August 30, 1982

Subject: Dresden 2
SEP Topic: VI-10.B, Shared Engineered Safety Features
On-Site Emergency Power, and Service Systems
for Multiple Unit Facilities

NRC Docket No. 50-237

DIESEL OIL STORAGE TANK

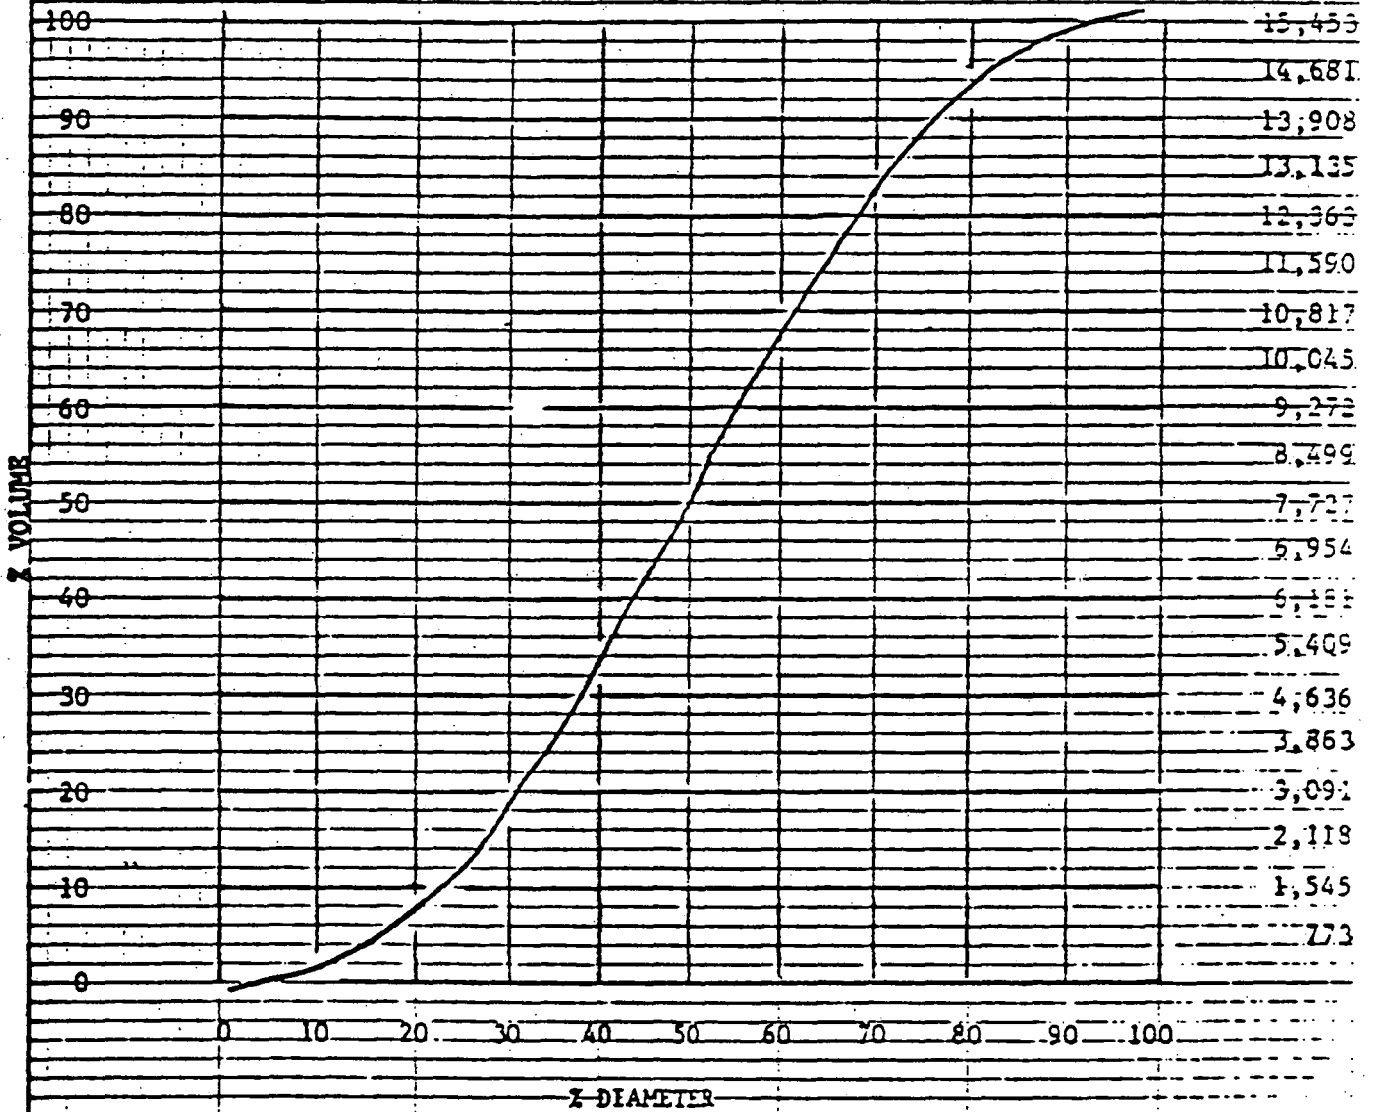
Stored energy for DG operation does not meet the seven-day minimum (or time to replenish, whichever is longer) required by current licensing criteria.

The underground diesel fuel storage tanks each have a capacity of greater than 15,000 gallons. By administrative controls, level indication is recorded for all 3 underground tanks once per shift on the "A" Operator Rounds, and is reviewed by the Shift Supervisor. Minimum permissible level by this procedure without initiating refill is 66% of tank diameter, or 11,899 gallons (see attached conversion table and capacity chart). Also, minimum day tank level before automatic refill is 500 gallons (2/3 capacity). Fuel consumption has been calculated as 173 gallons per hour for the first two hours post accident, and 147 gallons per hour thereafter. Therefore, minimum available storage capacity for any diesel is 84 hours or 3.5 days under expected load conditions. In addition, a low-level alarm in the control room will annunciate at a storage tank level of 6950 gallons, approximately a 2 day supply. The level indication and alarm on the storage tanks are calibrated annually per DIS 5200-1.
